4th Session SEISMIC EFFICIENCY OF LARGE STRUCTURES (RECOMMEN
DATIONS, CHECKING AND SURVEILLANCE)

DISCUSSION

Paper 4/1 R. PRISCU, A. POPOVICI, C. STERE - ROMANIA

"The Consequences of Partially Grouted Joints Upon the Arch Dam Seismic Behaviour"

Principal stresses σ_1 , σ_2 produced by hydrostatic pressure, according to the three analysed variants.

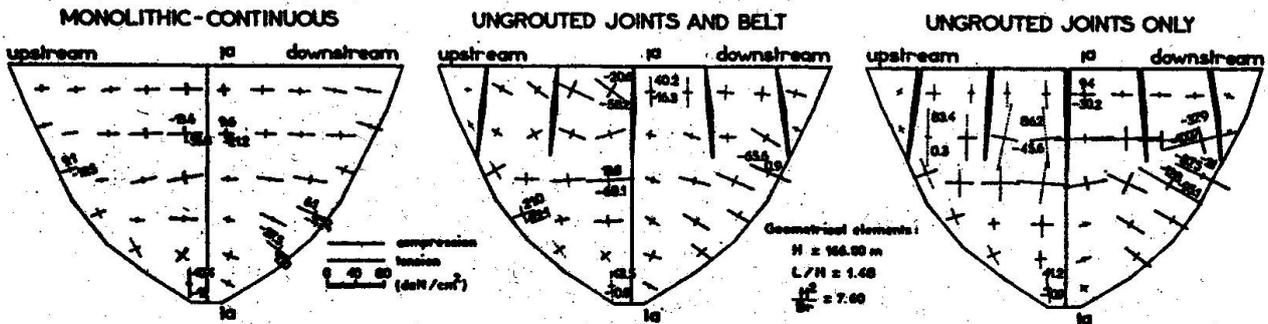
I believe that the ordinates of fig. 4 are all ten times too large and a decimal point should be added; also in fig. 7 I find it difficult to understand the large horizontal stresses in the area where the joints are ungrouted.

The dam structure discretization has been carried out through Clough-Fellipa thin shell finite elements, according to the SAP IV program /6/. The computer program gives out stresses within the element centers. Therefore, in fig. 7, the horizontal and vertical stresses are represented for the medium cross-section of the dam central block (cross-section a-a).

As to have a more complete picture upon the stress distribution of the three considered schemes (monolithic, partial grouted joints with and without stiffening crest belt), in the hereby enclosed figure the principal stresses σ_1 , σ_2 are presented, yielded by the hydrostatic pressure with the reservoir level up to the dam crest.
